Access Compliance Report

Public Rights-of-Way

(Curb Ramps)

Intersection ID: 23663	Main Street: S_TRYON_ST	Cross Street: ERWIN_RD	Location: N
ADA ID: 2943CC4E1C01	Ramp Type: PerpDiag	Initial Pass/Fail: Fail	Overall Compliance: No
Severity Score: 12.5			
Codes/Mitigation Info/Possible Solution		Field Measurements/Component Compliance

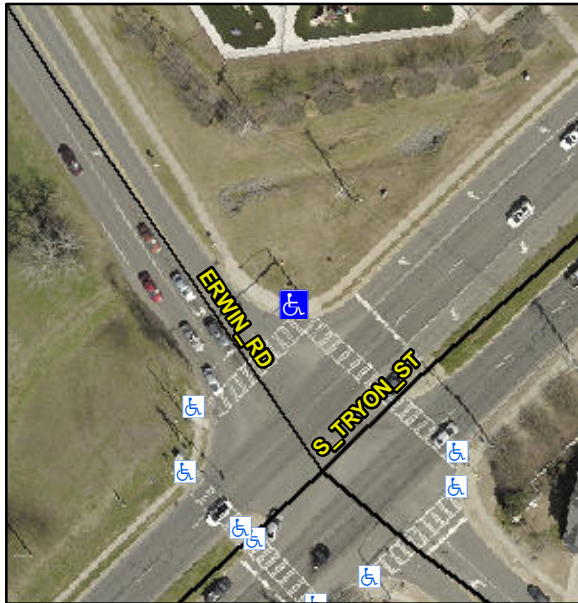
Not Found, R304.2.2

Compliance	Description	Data	Compliance	Description	Data
N/A	Ramp Length (in)	41.0	No	Ramp Slope (%)	10.5
Yes	Ramp Width (in)	48.0	Yes	Ramp XSlope (%)	1.1
N/A	Flare Type LT	N/A	N/A	Flare Type RT	N/A
N/A	Flare Slope LT (%)	N/A	N/A	Flare Slope RT (%)	N/A
N/A	Flare Traversable LT?	N/A	N/A	Flare Traversable RT?	N/A
N/A	Landing Length (in)	N/A	N/A	DWS Provided?	N/A
N/A	Landing Width (in)	N/A	N/A	DWS Contrast?	N/A
N/A	Landing Slope (%)	N/A	N/A	DWS Length (in)	N/A
N/A	Landing X Slope (%)	N/A	N/A	DWS Full Width?	N/A
N/A	Landing Curb? (Y/N)	N/A	N/A	DWS Offset (in)	N/A
N/A	Shared Landing?	N/A			
N/A	Gutter Ponding?	N/A	N/A	Gutter Slope (%)	N/A
N/A	Gutter Lip Ht (in)	N/A	N/A	Gutter X Slope (%)	N/A
N/A	Painted X Walk1?	Yes	N/A	Painted X Walk2?	Yes
	X Walk 1 Direction	To SW		X Walk 2 Direction	To SE
N/A	X Walk 1 Width (in)	120.0	N/A	X Walk 2 Width (in)	111.0
	X Walk 1 Slope (%)	1.9		X Walk 2 Slope (%)	1.8
	X Walk 1 X Slope (%)	1.3		X Walk 2 X Slope (%)	0.2

Remove & Replace Curb Ramp With Two New Directional Ramps or Equivalent.
